REMARKS/ARGUMENT

FIG. 11

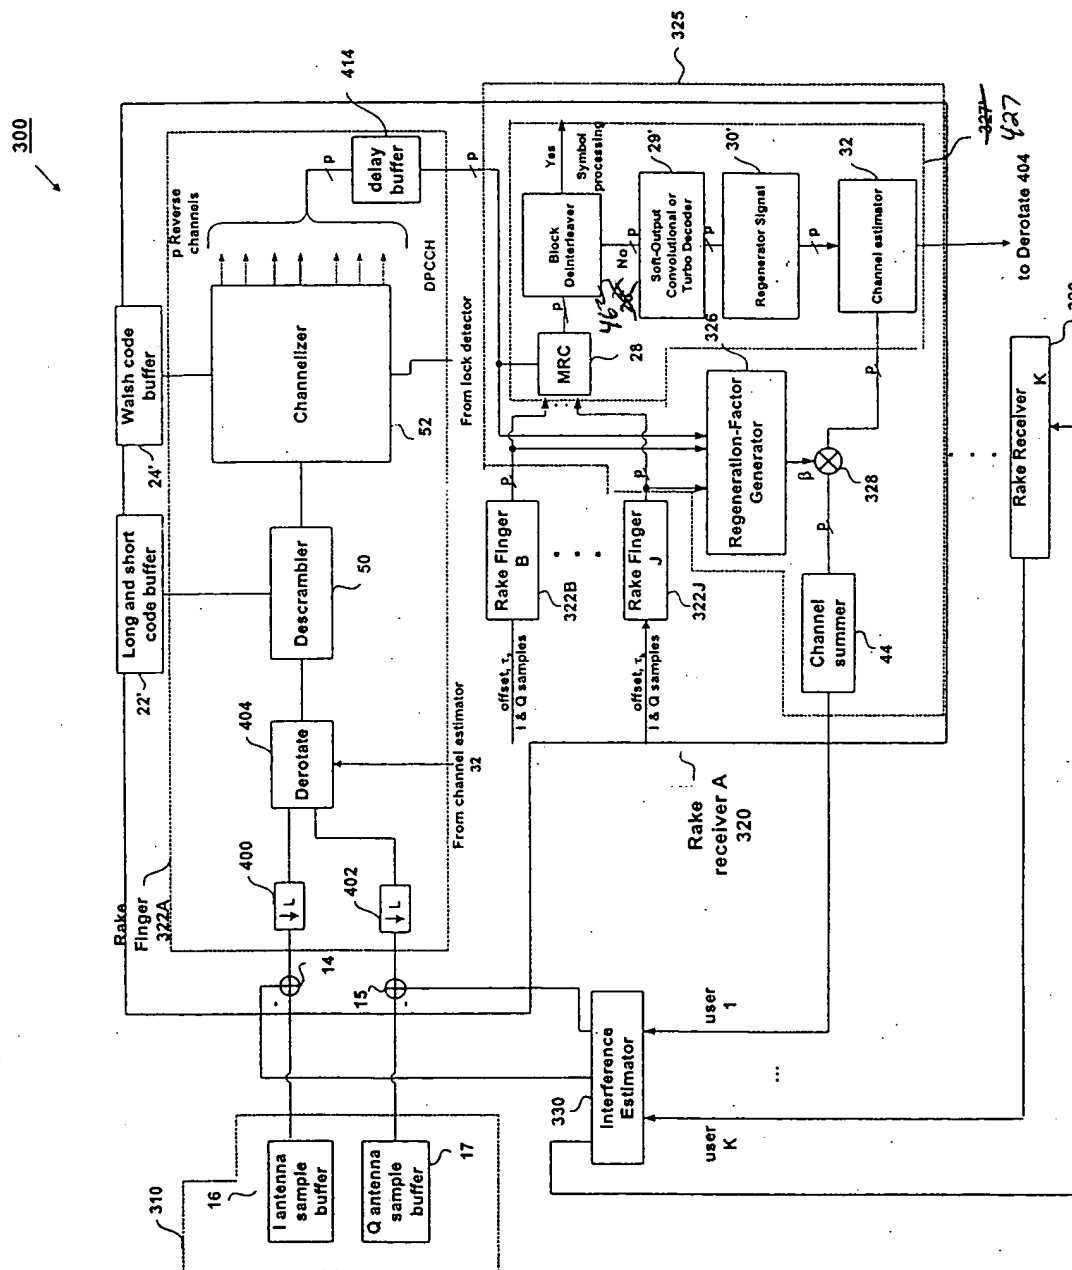
Applicants propose amending reference numeral “26” in Figure 11 to instead be “46”. Applicants further propose amending reference numeral “327” to instead be “427”. The proposed amendment overcomes the Examiner’s objection to the drawings.
